SUMMARY CHANGE NOTICE – ARINC 757-5 and ARINC 757A

ARINC CHARACTERISTIC 757-5 (Change 1)

ARINC CHARACTERISTIC 757A (Change 1)

COCKPIT VOICE RECORDER (CVR)

ATTACHMENT 3
 CVR INTERWIRING DIAGRAM WITH REMOTE MICROPHONE
 (DC POWER SHOWN)

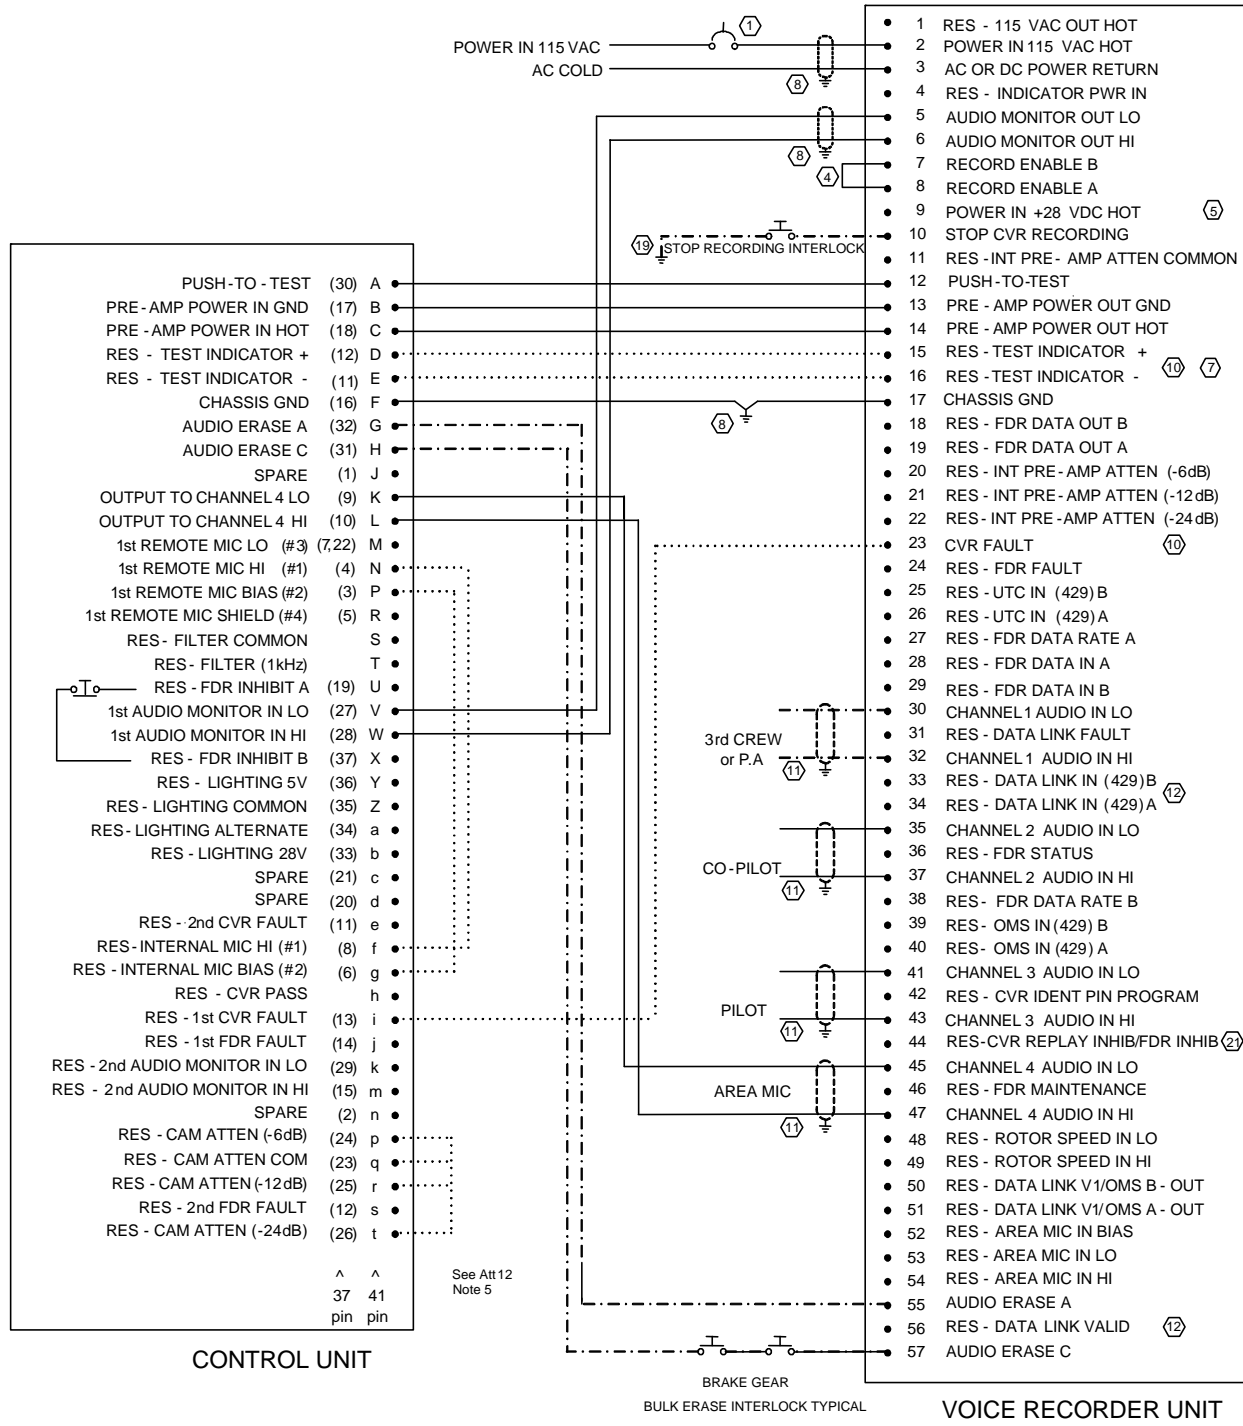
Drawing showing the “AREA MIC” connection calls out Note 12 in error. This is corrected to read Note 11.

**ATTACHMENT 10
MICROPHONE AND CABLE**

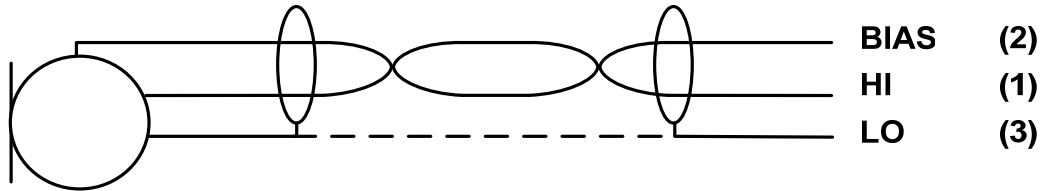
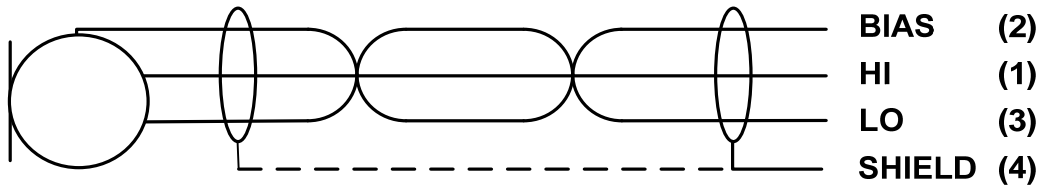
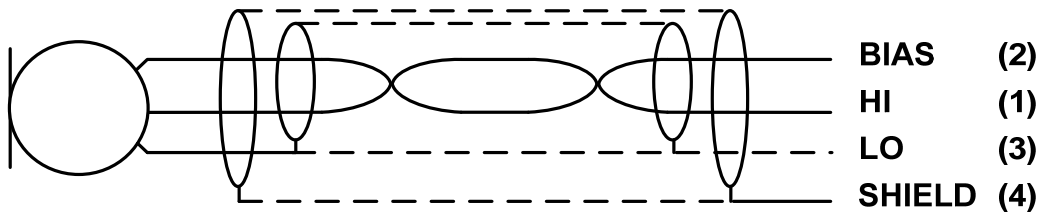
The drawing is viewed to be complete for ARINC 757 CVR installations. This drawing is re-drawn for artistic purposes only. (Note a similar drawing is included in ARINC 757A with changes.)

ATTACHMENT 3 – CVR INTERWIRING DIAGRAM WITH REMOTE MICROPHONE (DC POWER SHOWN)

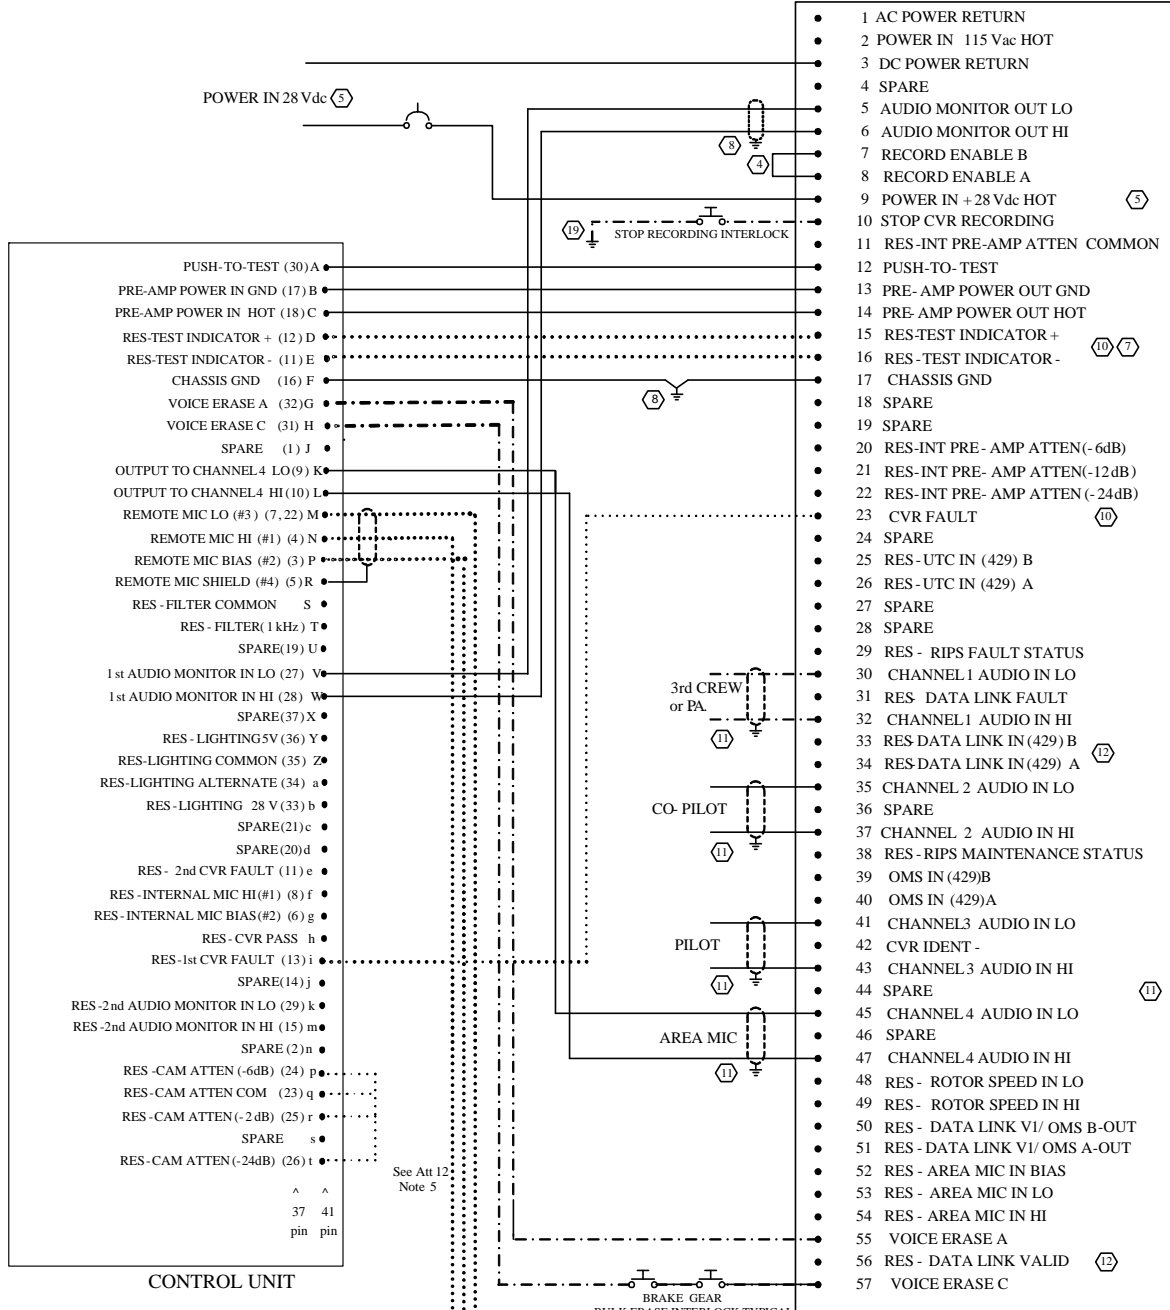
Drawing showing the “AREA MIC” connection calls out Note 12 in error. This is corrected to read Note 11.

**ATTACHMENT 10
MICROPHONE AND CABLE**

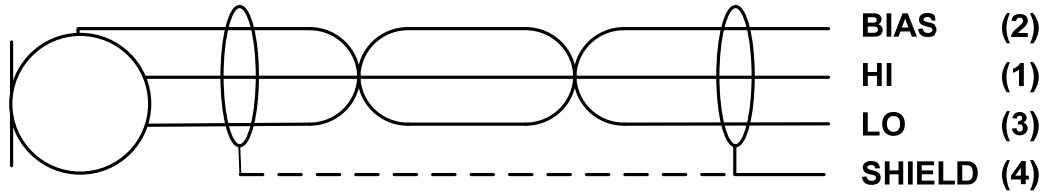
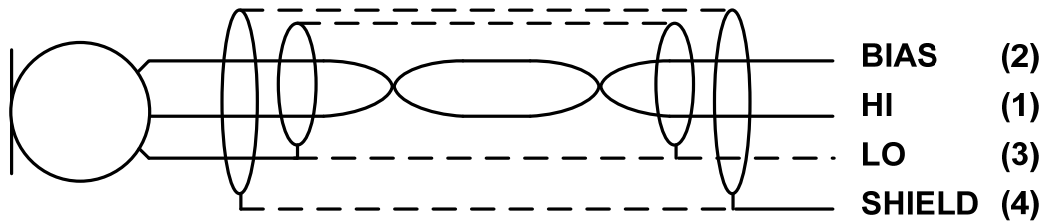
The drawing is updated for ARINC 757A CVR installations using a 3-wire microphone.
